Docket Item # 4
BAR CASE # 2013-0219

BAR Meeting
September 25, 2013

ISSUE: Signage and Alterations
Waiver of Rooftop Mechanical Screening Requirement; Section 6-403(B)

LOCATION: 801 & 803 King Street

A100

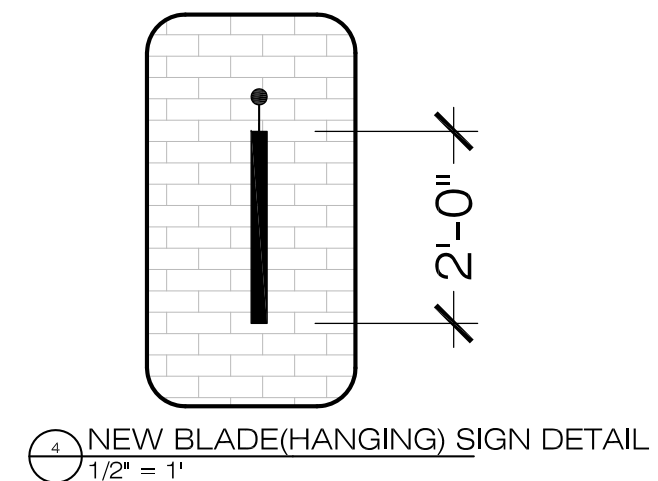
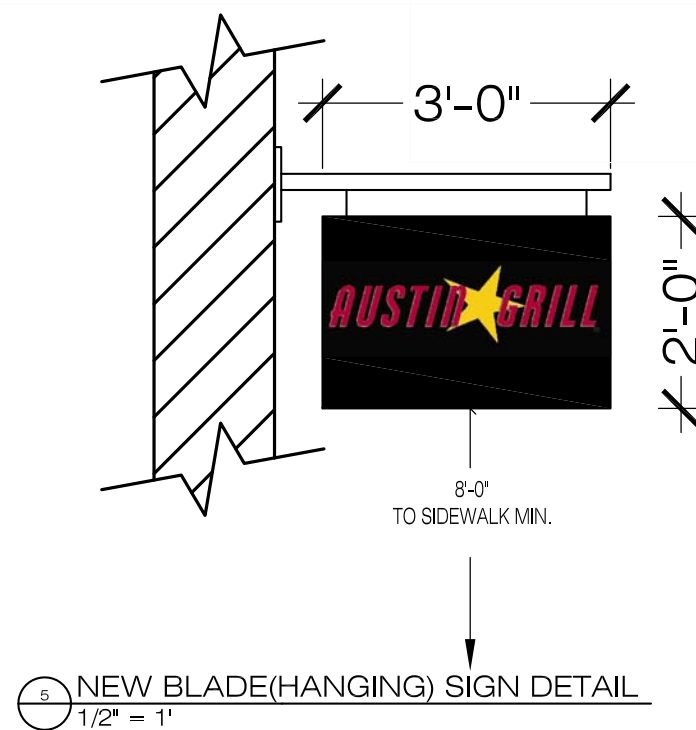
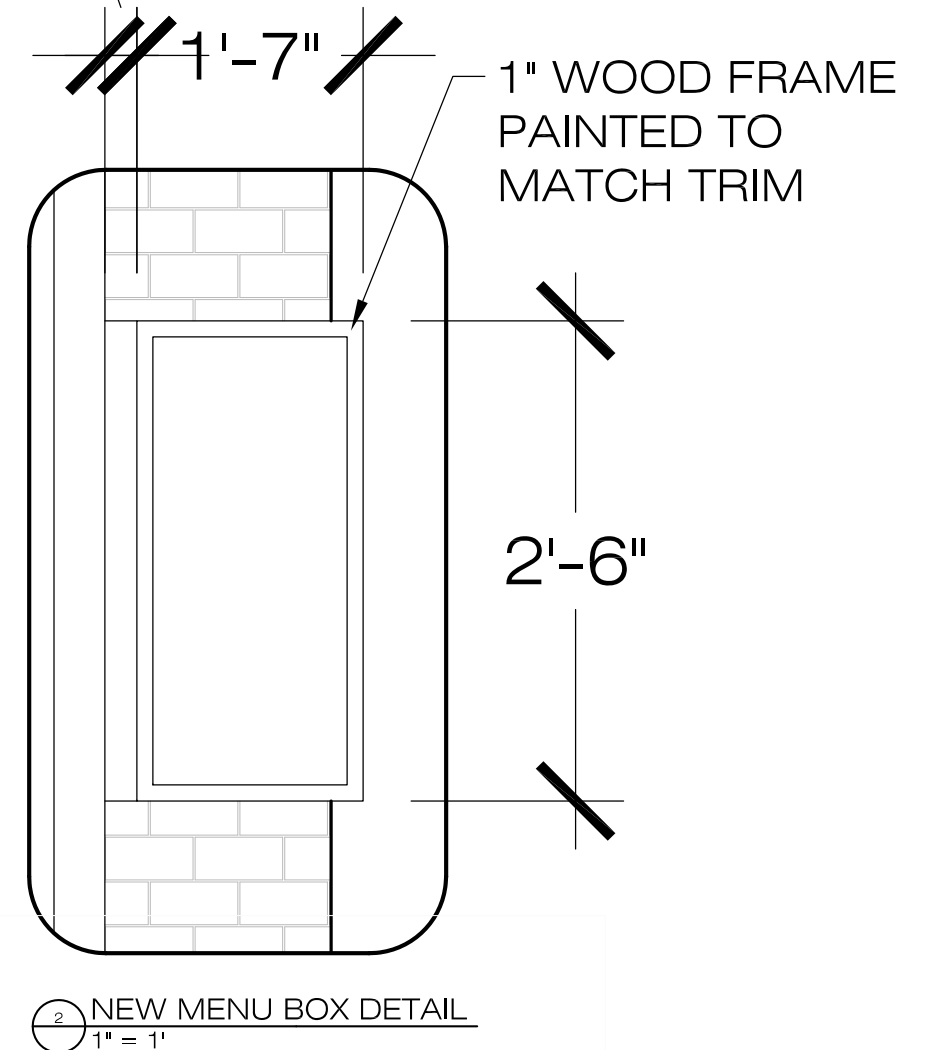
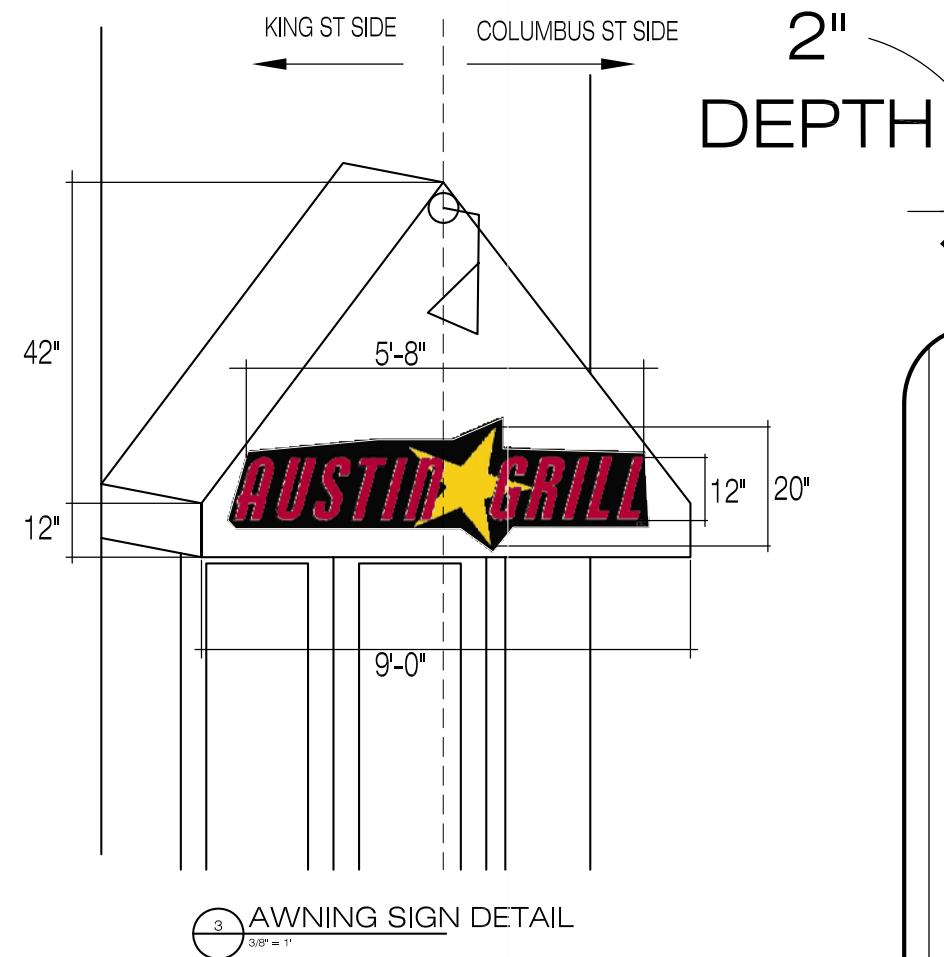
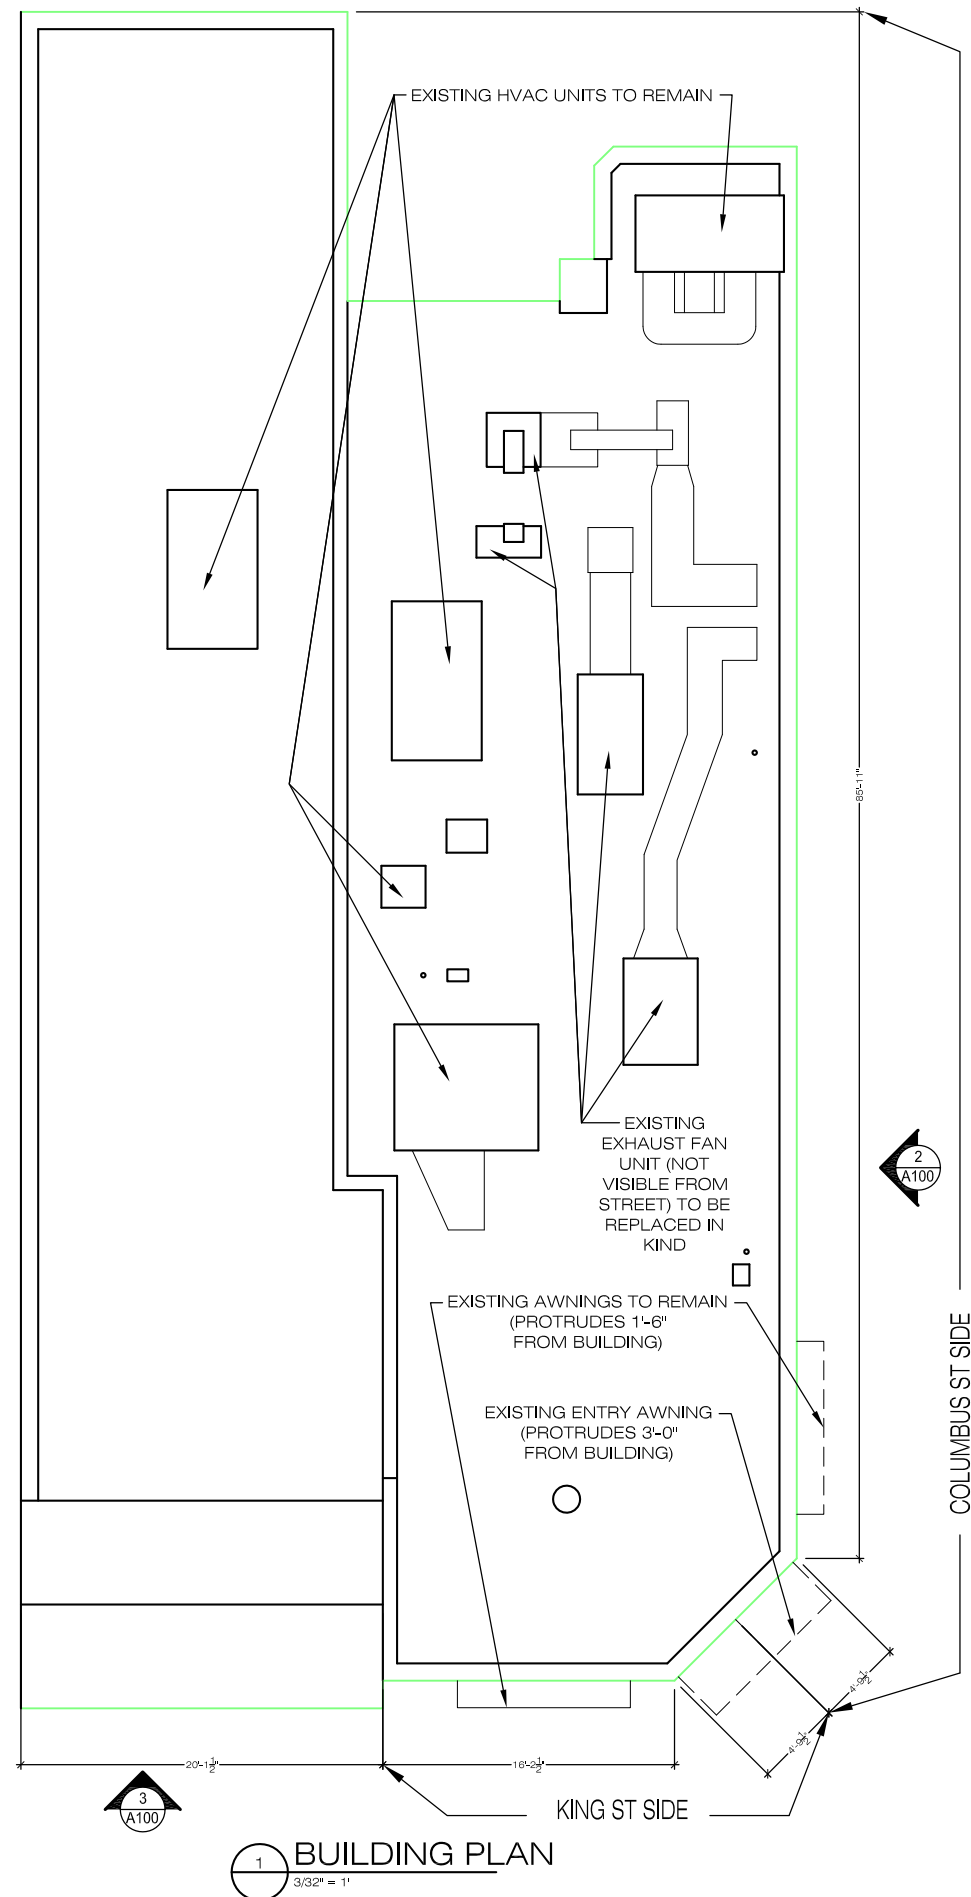
The applicant has noted on the entry door detail on page A100, that additional text will be added to the front doors. The zoning ordinance allows businesses to have up to a total of one square foot (144 square inches) of window decal sign area to provide relevant contact information, such as hours of operation, a phone number, a web address, a QR code, or other to-be-developed technology, without any review. The one square foot will count toward the total sign area for a building but will not count toward the total number of signs permitted. Information in excess of this one square foot requires BAR approval and must conform with the Board's amended sign policy. Contact information may not be included on wall signs, hanging signs or awnings. Window decal signs applied to a glass door or the lower half of a window are preferred. The applicant should ensure that the information being installed on the doors complies with these regulations.

C-2 Proposed sign on awning appear larger than the window signs, but dimensions are the same. Applicant must confirm dimensions are the same for awning and window signs.

1. That the applicant clarify the outstanding zoning questions during building permit submission;
2. That Staff approve the final entry door information signs to verify compliance with the Board's sign policy; and
3. That the conduit that is utilized for the sconces will be painted to match the adjacent wall color.
